Joseph M. Farley Nuclear Plant - Units 1 and 2  
Proposed Technical Specification Change  
to D.C. Distribution System Requirements

## Specific Comments - Battery Technical Specification Change

FIGURE 2

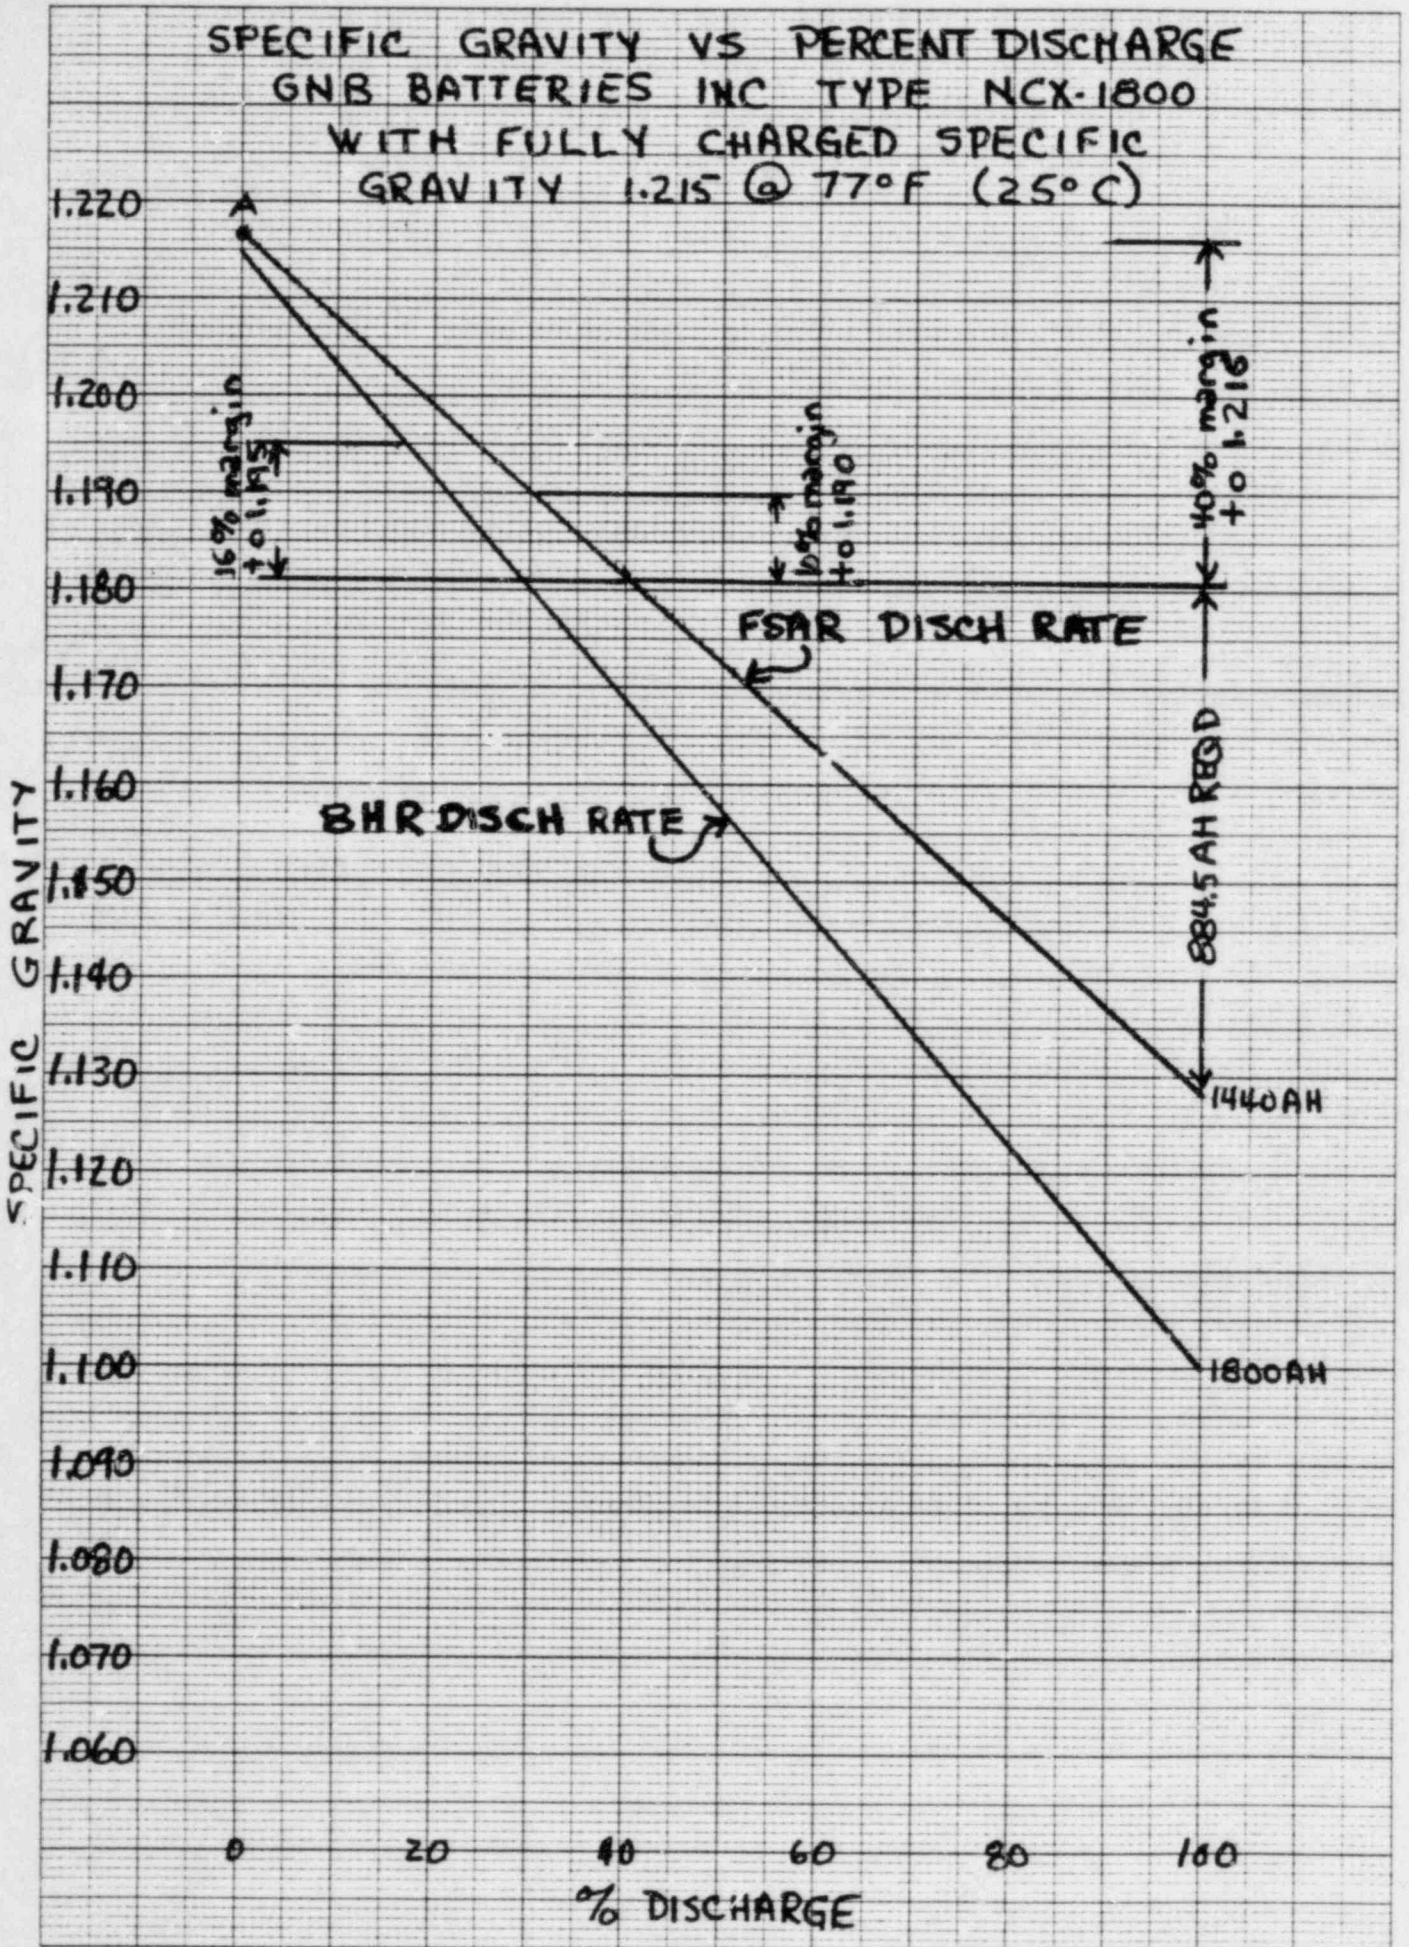
The NRC proposes that the specific gravity for the average of all connected cells be greater than or equal to 1.205. APCo proposes that the specific gravity be 1.195 which is based on the FSAR required loads plus an adequate margin of 16%. The minimum average specific gravity to meet the FSAR loads is approximately 1.181 as shown in Figure 2 of Attachment 4.

5. The FSAR Discharge Rate on Specific Gravity vs. Percent Discharge Graph was plotted (Figure 2) by drawing a line beginning at 1.216, the specific gravity value at 0% discharge, and ending at 1.163, the specific gravity where the battery is 61% discharged. Extending the straight line to the 100% discharge point (1440 AH) gives a specific gravity of 1.128.

7. The specific gravity range required to deliver the FSAR load is equal to:  
 $1.216 - 1.163 = .053$  (from actual test data as plotted).
8. If we want to determine the minimum beginning specific gravity, we start from the lower specific gravity limit of 1.128 which represents 100% discharge (at FSAR rate). We then add the specific gravity range required to meet FSAR loads ( $1.128 + .053 = 1.181$ ). 1.181 is the minimum specific gravity to start from where battery capacity would be equal to the FSAR assumed loads.

9. With the existing minimum specific gravity of 1.190 we can meet the FSAR loads with a margin of 10%. This margin is determined by subtracting the minimum specific gravity (from 8 above, from the APCo existing minimum value of 1.190 ( $1.190 - 1.181 = .009$ ). This is the difference between the minimum FSAR value and the existing acceptance value. The capacity margin provided by the existing acceptance value is determined by dividing this difference (.009) by the battery capacity specific gravity range from 0% discharge to 100% discharge [ $.009 / (1.216 - 1.128) = 10.02\%$ ]. This is the margin of battery capacity with existing Technical Specifications.

10. Similarly, for the APCO proposed average specific gravity limit of 1.195, the margin of battery capacity is;  $(1.195 - 1.181) / (1.216 - 1.128) = 16\%$  margin.
